AMENDMENTS TO THE DRAWINGS

REMARKS

FIG. 1A
PRIOR ART

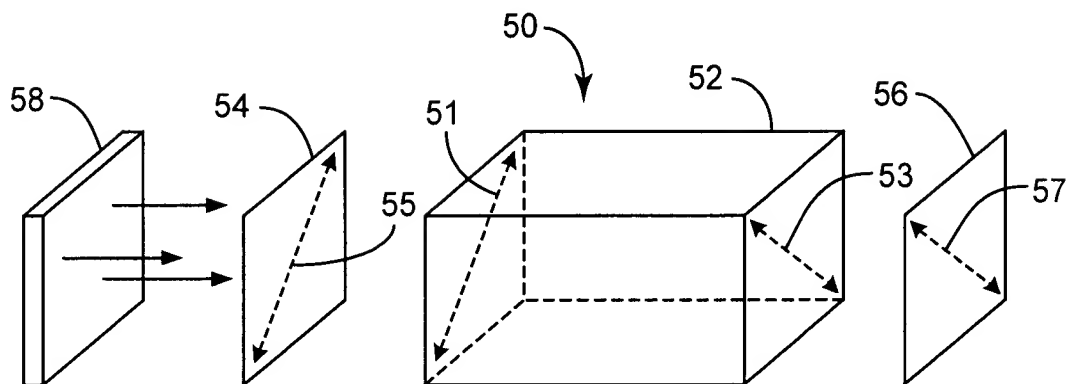
The drawings were objected to as not specifying FIG. 1A – FIG. 1C as “Prior Art”. Applicants have provided a replacement drawing page in compliance with 37 CFR 1.121(d) herewith. Withdrawal of the objection is respectfully requested.

Added

FIG. 1B
PRIOR ART

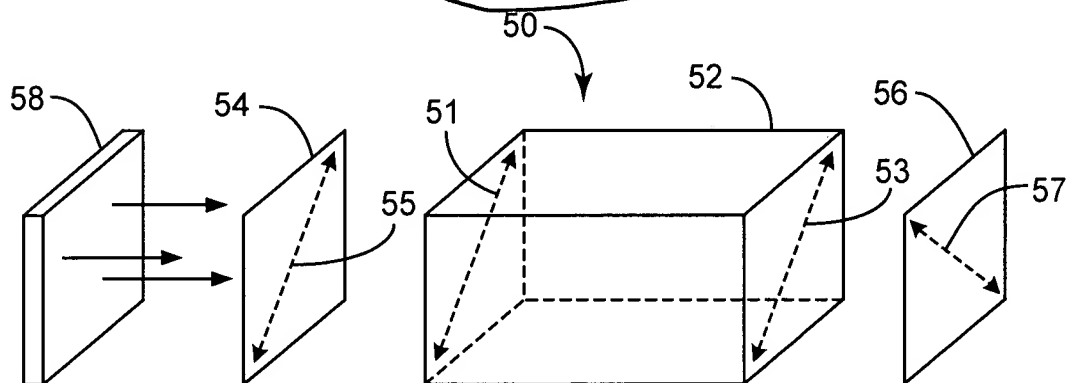
Added

FIG. 1C
PRIOR ART

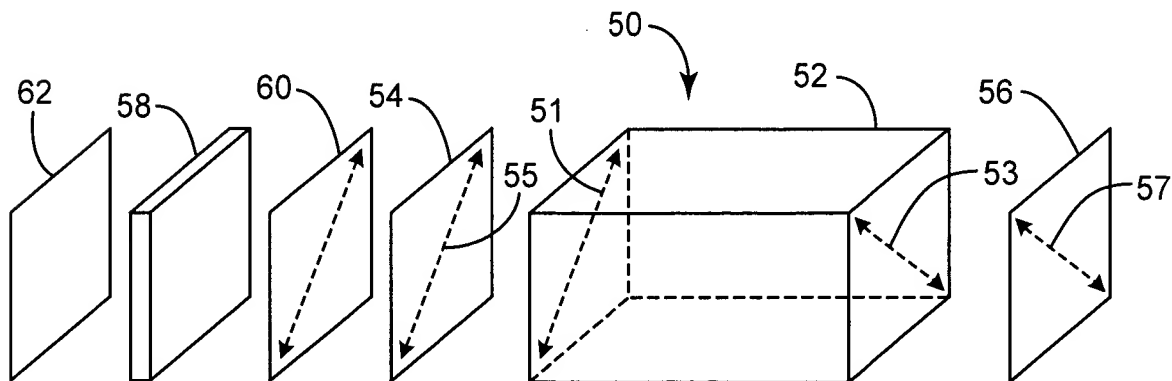
added
